Re: Westlands' Broadview Aquifer Storage and Recovery (ASR) Project (DWR Grant Agreement No. 4600013845 Proposition 1 Funding) – Adequacy of Hydrologic Analysis, CEQA Compliance and Potential for Mobilizing Contaminated Shallow Groundwater

Potential Hydrologic and Water-Quality Effects of an Aquifer Storage and Recovery Well in Broadview Water District

Prepared by:
HydroFocus, Inc. Davis, CA
March 16, 2022

Figure 3. Model domain and map view of cross section A-A' from LSCF 2019 (Figure 2-1) and LSCF 2020 (Figure 3-1).

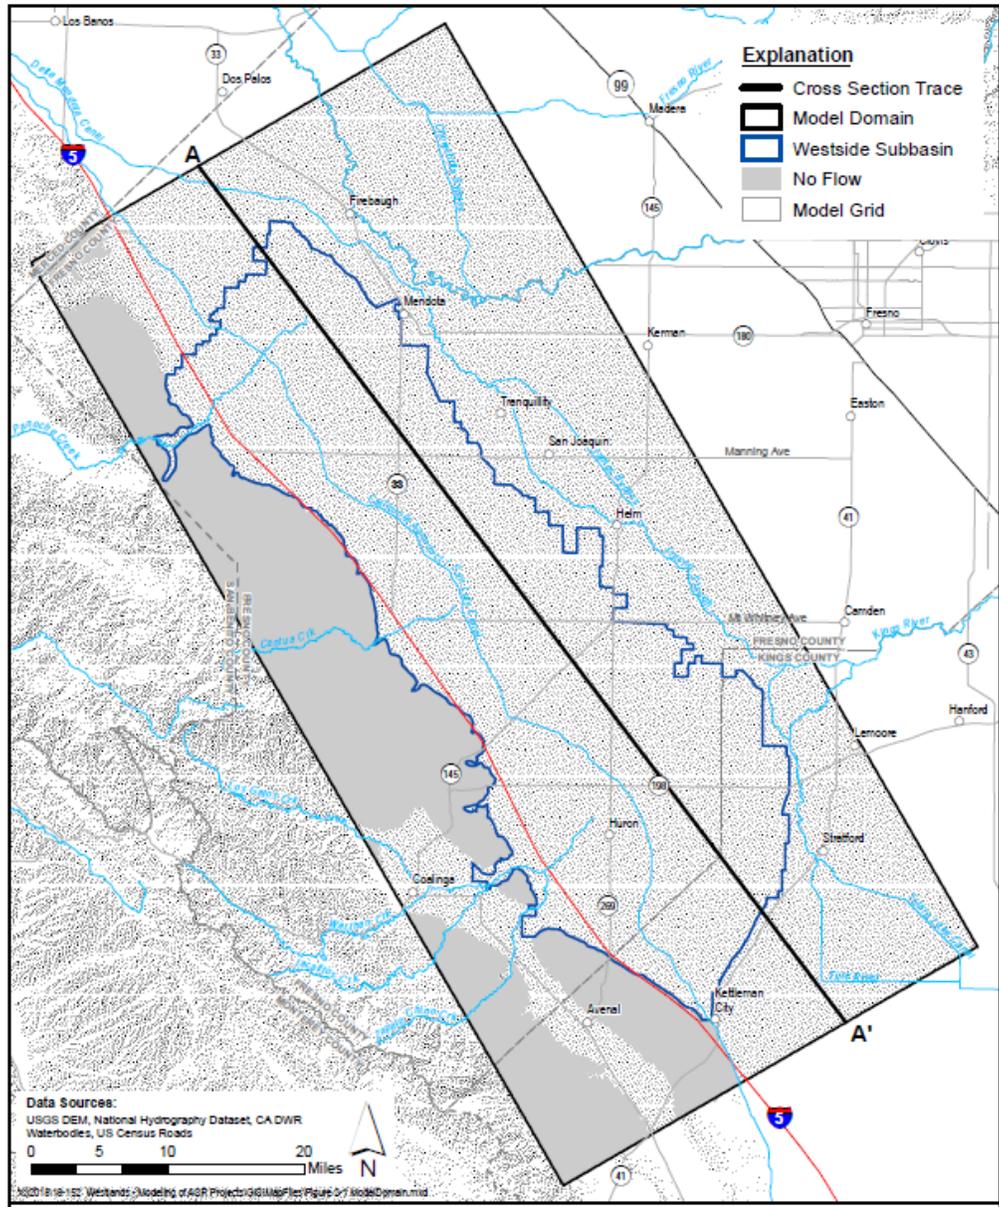
Consistently, LSCE (2020) stated in the Groundwater Sustainability Plan (LSCE, 2020) for the Westside Subbasin stated that “The A and C-Clays are restricted to a narrow band below the Fresno Slough floodplain area (Croft, 1972). The northern extent of these upper Lake Beds is not well known.” A northwest-southeast cross section illustrating the groundwater model discretization of the lithology, used in both LSCE (2019) and for the Groundwater Sustainability Plan, does not show the presence of the A, B, C, or D Clays for much of the basin (Figures 3 and 4). Specifically, figures 3 and 4 do not show the presence of the A-Clay in BWD.

As stated above, the available evidence discussed above indicates that the A-clay is not present in BWD and there are multiple lines of evidence for the connection between the shallow and deep zones within the semiconfined zone. Moreover, LSCE (2019, 2020) did not include a continuous A-clay in the groundwater flow model and the A-clay is absent in the BWD area (figures 3 and 4). In addition, LSCE (2019) stated that “The assignment of model hydraulic properties is based on a stochastic model of subsurface hydrofacies architecture [...] in locations where there is no subsurface data included in the conditional simulation, the arrangement of low and high permeability material is determined by a random process and likely not representative of local geology [...]”

Figure 5. Locations of ASR wells simulated in the LSCE model (modified from Figure 3-2 in LSCE, 2019). The area outlined in red is BWD. The planned ASR well within BWD was not included in the original Figure 3-2.

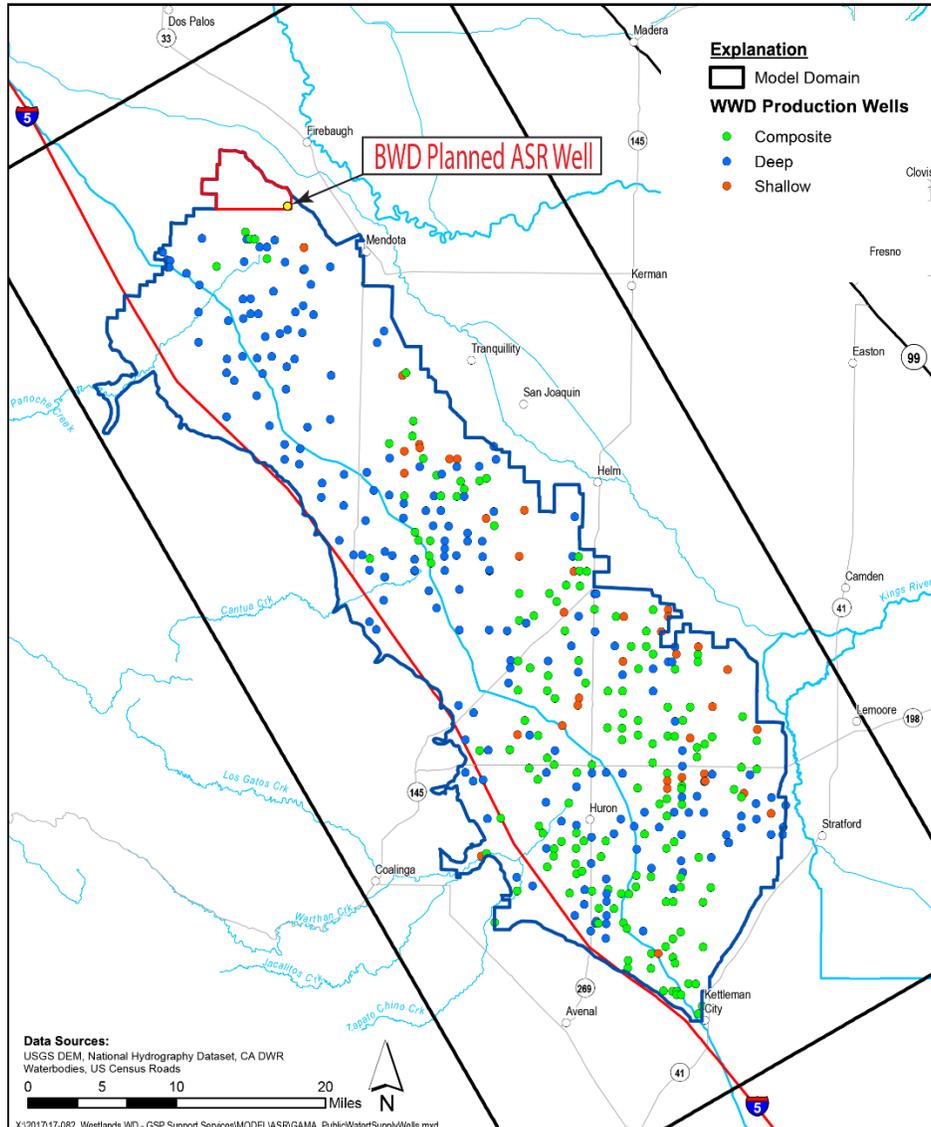
Based on the available documentation, the proposed BWD ASR well was not simulated in the LSCE model. Figure 5 shows the proposed location of the BWD ASR well which was not included among the ASR wells simulated in the LSCE model. It is unclear what area is referred in Figure E-3C in the Westlands response to comments. In Figure E-3C, simulated groundwater elevations within BWD range from 150 – 190 feet above sea level. Based on Google Earth imagery, land surface elevations range from about 178 to 212 feet above sea level, much less than the 240 feet claimed in the Westlands response.

In conclusion, the available information indicates that more work is required to effectively simulate the Broadview ASR project. There are four apparent model deficiencies. First, based on the available documentation, the LSCE model did not simulate the proposed BWD ASR well. Second, the LSCE model is based on a paradigm of discontinuity between the deep and shallow zones within the semiconfined zone. This contrasts with peer-reviewed modeling results presented by Belitz et al. (1993, 1995) and evidence described above under question 1. Third, the LSCE model does not explicitly simulate agricultural drains for the areas east of BWD where drains collect shallow groundwater and, based on Deverel and Fio (1991), influence groundwater flow in the semiconfined zone. Fourth, sensitivity analysis is missing which can provide an understanding of the level of confidence in model results. Data collection in conjunction with an ASR well test will be essential for addressing these three issues. We conclude that the LSCE model in its current form is not an appropriate tool to effectively assess hydrologic and water quality effects related to the BWD ASR well.

Figure 6. Most recently reported depth-to-groundwater measurements in wells <30ft deep in and around BWD. Groundwater measurement data was provided by CASGEM.

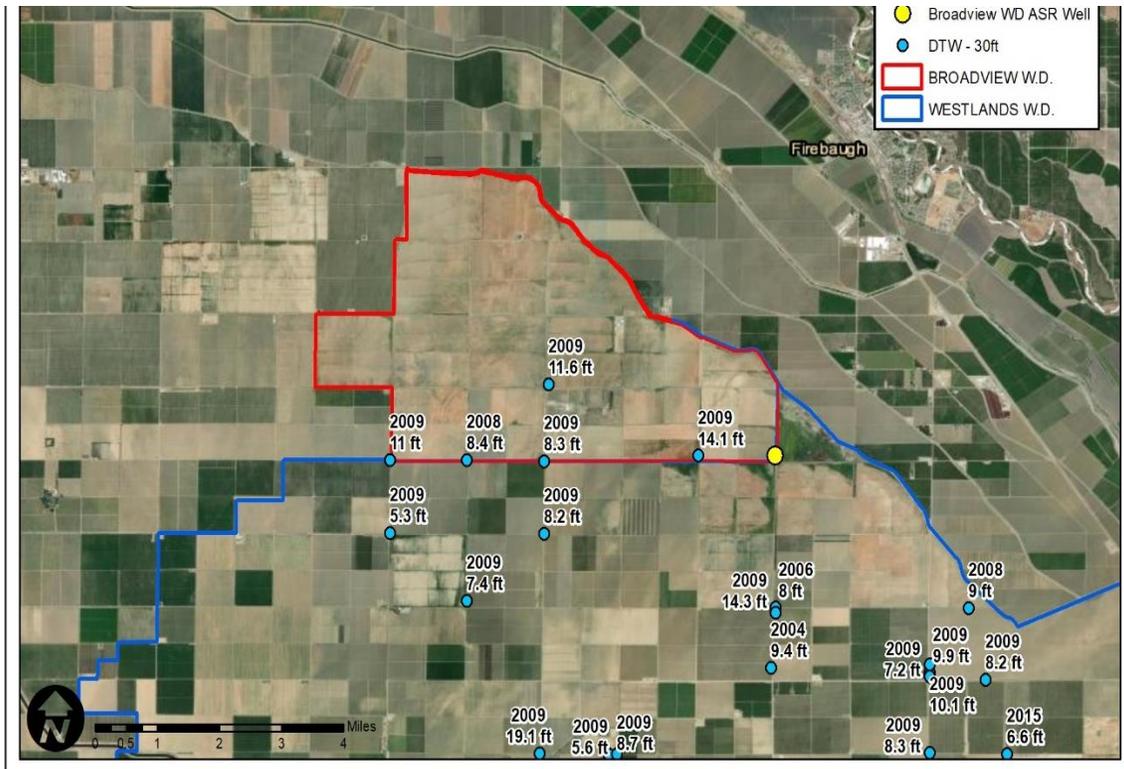
Figure 6 shows the most recent depth-to-groundwater (DTW) measurements retrieved from CASGEM for wells in and near the BWD with a total well depth of no more than 30 feet. The planned ASR well within BWD is plotted in the southeast corner of BWD. The water levels in wells within and near BWD were last measured in 2009. In the well within BWD, the depth to groundwater was measured at 11.6 feet below land surface in 2009. In the monitoring well nearest to the planned ASR well, the measured depth to groundwater was 14.1 feet. The average depth to water in the five wells within, or on the immediate edge of, the BWD was 10.7 feet. Considering that irrigation ceased and there was no drain flow in BWD after 2005 as per the Westlands response letter, the 2009 groundwater level data indicate that in the absence of water application, shallow groundwater levels likely persist. Injection of water into the BWD ASR well could increase the shallow groundwater levels and potentially reinstate drain flow in BWD and increase shallow groundwater movement to Mud Slough. Monitoring should address this possibility.

Based on the study results described previously, injection of water into groundwater wells can induce changes in the shallow groundwater and laterally in the semiconfined zone. Therefore, we recommend that monitoring of the hydraulic effects of aquifer storage and recovery be designed to evaluate vertical and horizontal effects of injection and pumping. Piezometers should be installed adjacent to ASR wells to varying depths ranging from 10 to 50 feet below land surface at varying distances from the well up to about 200 feet. We recommend that groundwater levels be monitored continuously using transducers. This will provide insight about the processes affecting ground levels changes and the potential for reinitiating drain flow.

Moreover, regular water-level monitoring of monitoring wells within the BWD area should be undertaken to assess potential regional effects. Groundwater quality samples should be collected from the piezometers to assess the levels of salinity and selenium and other constituents of concern identified within the Grasslands Bypass Project. Considering the shallow groundwater levels that likely exist within area adjacent to the proposed ASR well, drain flow and quality within BWD and Firebaugh Canal Water District should be monitored during the injection period. Groundwater hydrologic data can be used to compare with modeling results and thus provide an opportunity for model modification and validation.
